Landmark Commission

**September 18th, 2019
4:30 P.M.
City Commission Chamber
AGENDA**

LANDMARK COMMISSION REPORT

APPLICATION FOR DEMOLITION OF THE COOKE BUILDING AT 150-162 COLUMBUS AVE.

CHESAPECKE LOFTS EAST SIDE PARAPET WALLS

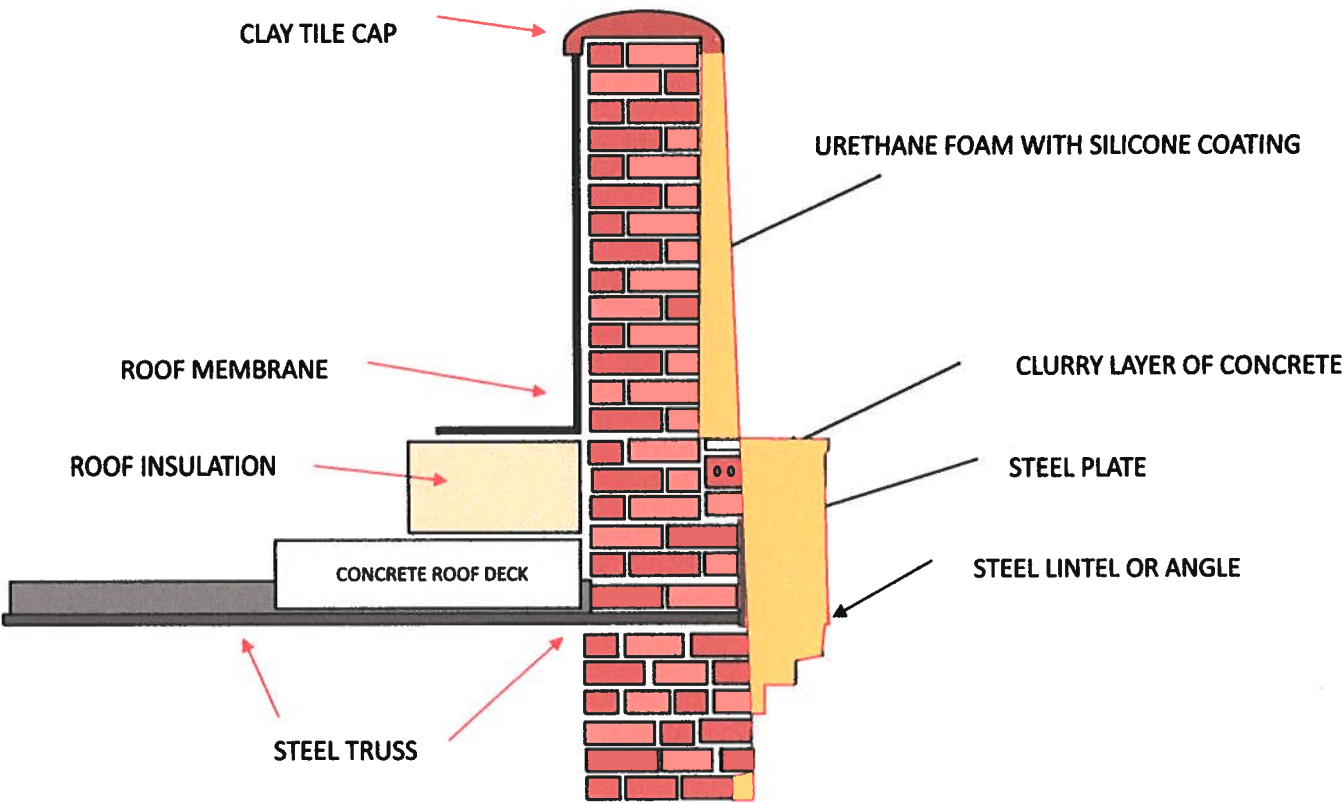
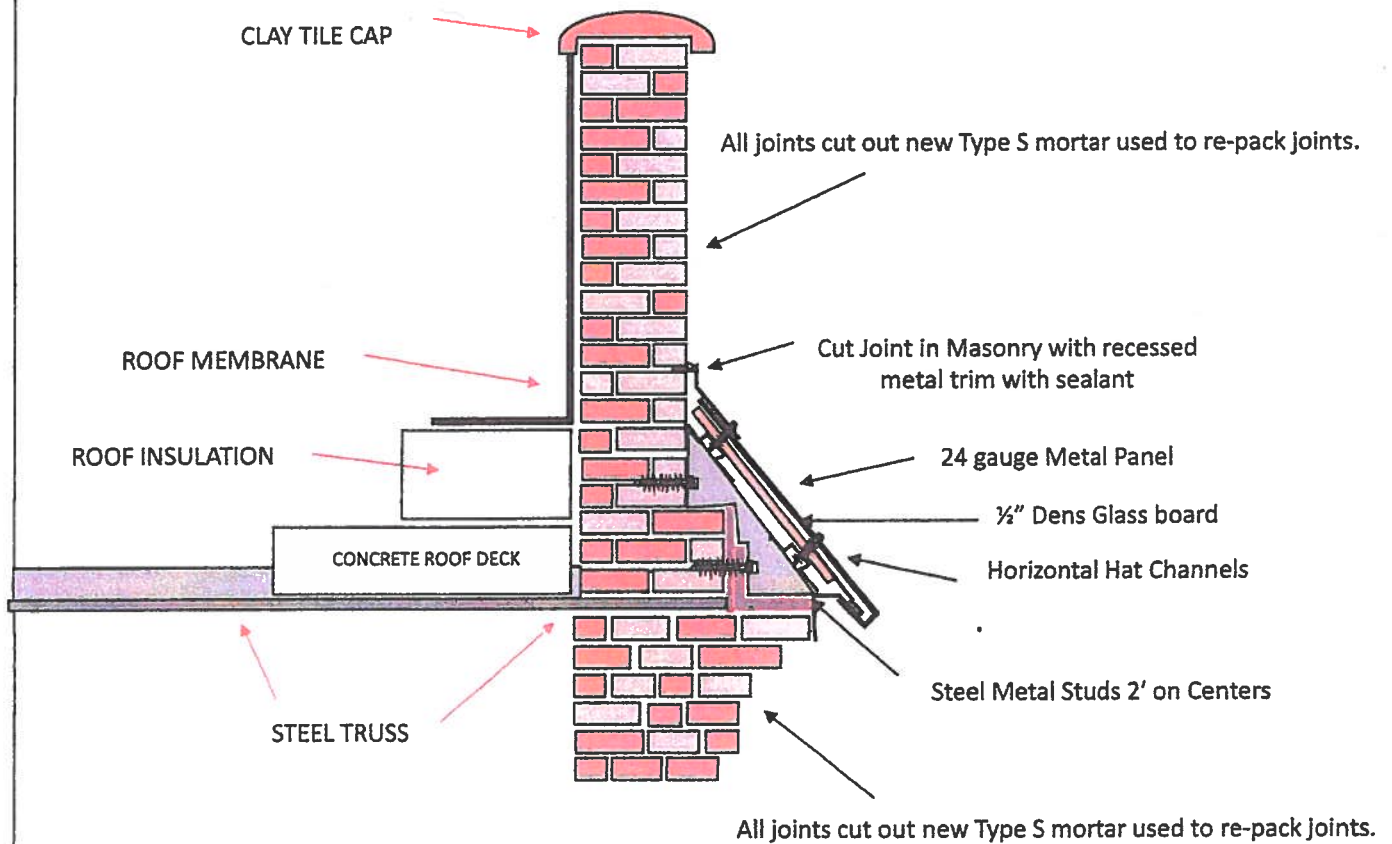
- Leakage into below units
- Loose bricks held with only a layer of foam surfacing.
- Support steel wet and deteriorating holding up the brick work in question.

The loose brick from deteriorated mortar is in a lot of area only setting on the inner steel. When this was original install the brick were laid with only masonry mortar and when the mortar deteriorated the bricks are only setting there. Mechanical ties would be incorporated into the repair which would be fastened into the steel for added support for the masonry.

Remove all the applied foam surfacing done to the existing masonry surface. Cut all masonry mortar joints above shelf and below in decorative brick so new high strength mortar can be repacked into every mortar joint. The horizontal mortar joint above the shelf will be cut out 3/4" in depth so a sloping metal cap can be installed to properly shed water off edge. On face of shelf the metal would also be secured into the top edge of the masonry face. The slurry concrete top surface, all the eyebrow brick shall be cut out and removed back to the steel lintel and plate and disposed of. Steel will be wire brushed of rust and primed and painted. By removing the masonry shelf you will remove over one hundred pounds in weight per foot of the structure.

The sloped cap top over the removed shelf area is cut into the masonry wall and packed with mortar, secured with fasteners and sealed at the metal top. The bottom edge is secured into the newly repaired masonry with a metal cleat to provide a secure lock.
